ENGINEERING TECHNICAL STATEMENT PREPARED BY WILLIAM T. GODFREY, JR. OF THE FIRM KESSLER AND GEHMAN ASSOCIATES, INC., TELECOMMUNICATIONS CONSULTING ENGINEERS IN CONNECTION WITH FILING COMMENTS ON THE PROCEDURES AND RULE CHANGES ADOPTED IN THE THIRD PERIODIC REVIEW OF THE COMMISSION'S RULES AND POLICIES AFFECTING THE CONVERSION TO DIGITAL TELEVISION WITH RESPECT TO THE UNIVERSITY OF HOUSTON SYSTEM (UHS) POST-TRANSITION DIGITAL BROADCAST FACILITY, KUHT-DT CHANNEL *8, HOUSTON, TEXAS.

The firm Kessler and Gehman Associates, Inc. has been retained by the University of Houston System (UHS), Houston, Texas, licensee of analog broadcast facility KUHT-TV Channel *8 and digital station KUHT-DT Channel *9, to prepare an engineering analysis with respect to the Third Periodic Review of the Commission's Rules and Policies Affecting the Conversion to Digital Television (Third DTV Periodic NPRM).

KUHT-DT Channel *8 Proposed Azimuth Pattern & Tabulation

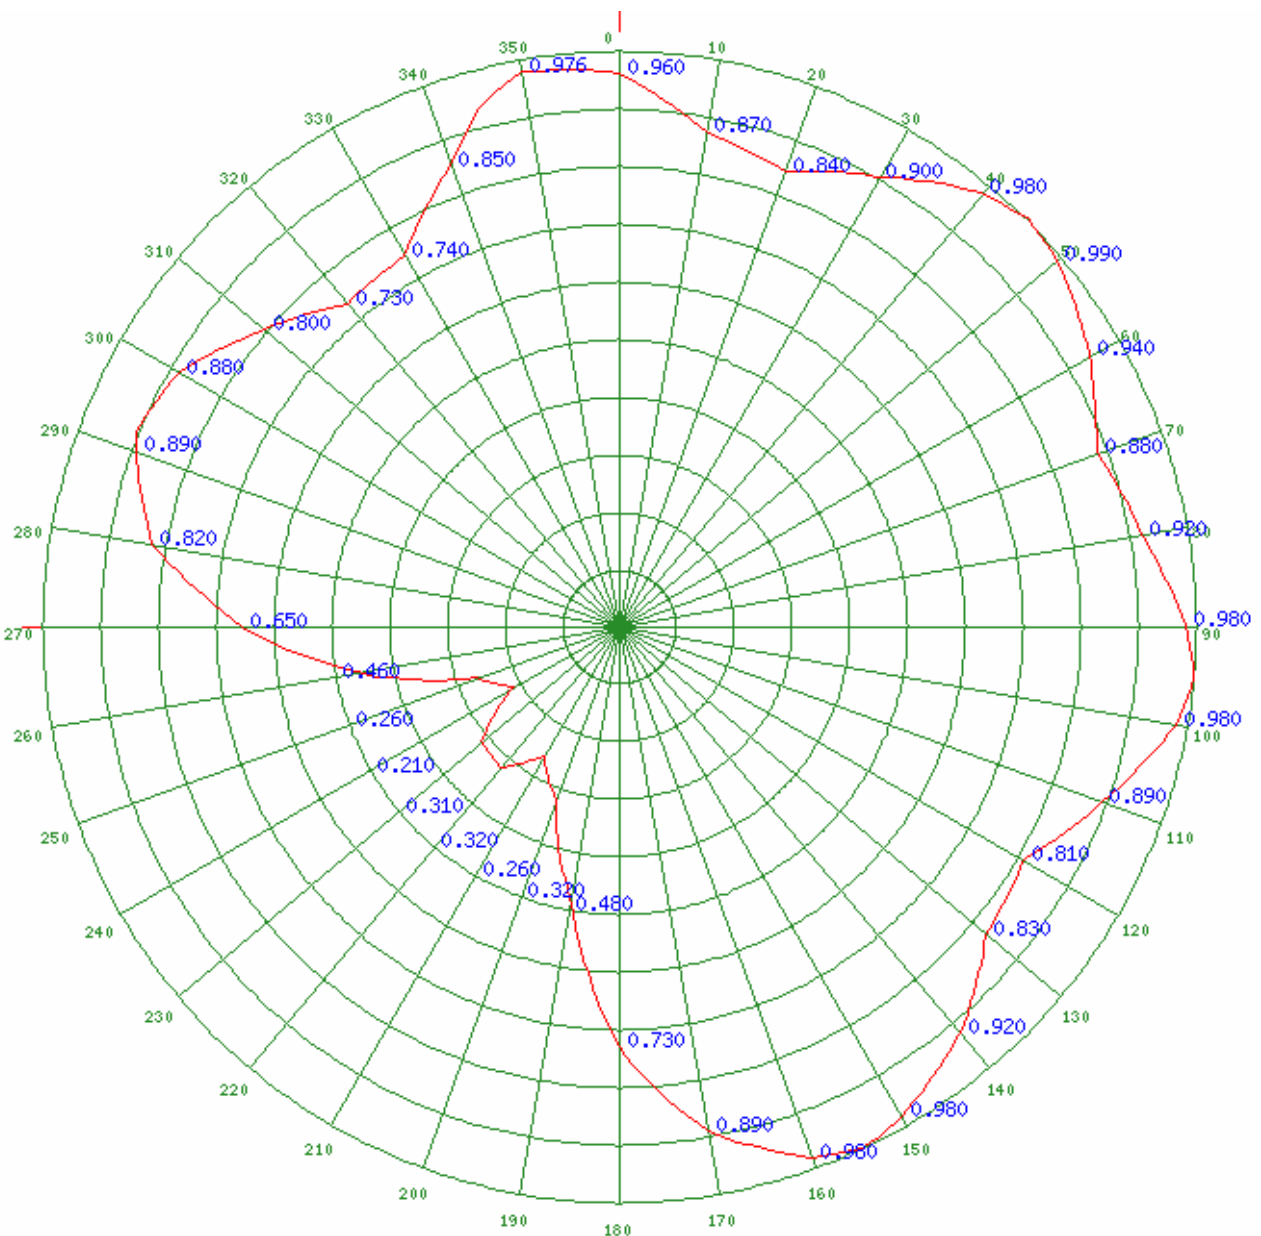
Exhibit 1 depicts the post-transition antenna azimuth pattern as specified in the Final DTV TOA (Antenna ID: 80228) and the Exhibit 2 depicts the licensed KUHT-TV Channel *8, licensed KUHT-DT Channel *9, and proposed post-transition KUHT-DT Channel *8 antenna azimuth pattern (Antenna ID: 18548). The azimuth pattern assigned in the Final DTV TOA and the licensed pattern used by KUHT-TV/DT and proposed for the post-transition facility are both directional cardioid patterns; however, the patterns are not identical. Exhibit 3 is a contour comparison map depicting the following: 1) KUHT-DT Channel *8 F(50,90) 36.0 dBuV/m protected noise limited contour (red) as specified in the Final DTV TOA; 2) proposed KUHT-DT Channel *8 F(50,90) 36.0 dBuV/m protected noise limited contour (magenta) using the licensed KUHT analog/digital dual channel antenna azimuth pattern; and 3) licensed KUHT-TV Channel *8 F(50,50) 56.0 dBuV/m protected Grade B contour (dashed black). Referring to Exhibit 3, it can be seen that proposed KUHT-DT Channel *8 facility using the existing antenna and 21.9 kW ERP (magenta contour) would come much closer to replication (dashed black) than the KUHT-DT Channel *8 post-transition facility as specified in the Final DTV TOA (red). In fact, the area that the KUHT-DT Channel *8 Final DTV TOA F(50,90) 36.0 dBuV/m noise limited contour (red) would exceed the proposed noise limited contour (magenta) is 448.25 sq. km while the area that the proposed noise limited contour (magenta) would exceed the Final DTV TOA noise limited contour (red) is only 360.52 sq km (see Exhibit 3). Therefore, UHS's request to have the antenna ID changed would actually reduce the size of its overall coverage contour by 87.73 sq. km which further confirms that UHS is not asking for more than it is currently authorized and is simply requesting an antenna ID change so that it can replicate and continue to serve the population it has served for so many years.

Table Appendix B facilities to the extent necessary to address the difference between the theoretical facilities specified in the new DTV Table Appendix B and the actual facilities which they are able to build? In response, UHS respectfully requests that stations be permitted to expand beyond their DTV Table Appendix B facilities when minor changes to antenna patterns are required to permit the station to replicate its current DTV facilities. In the case for UHS, the public interest would clearly be served by changing the antenna ID from No. 80228 to No. 18548.
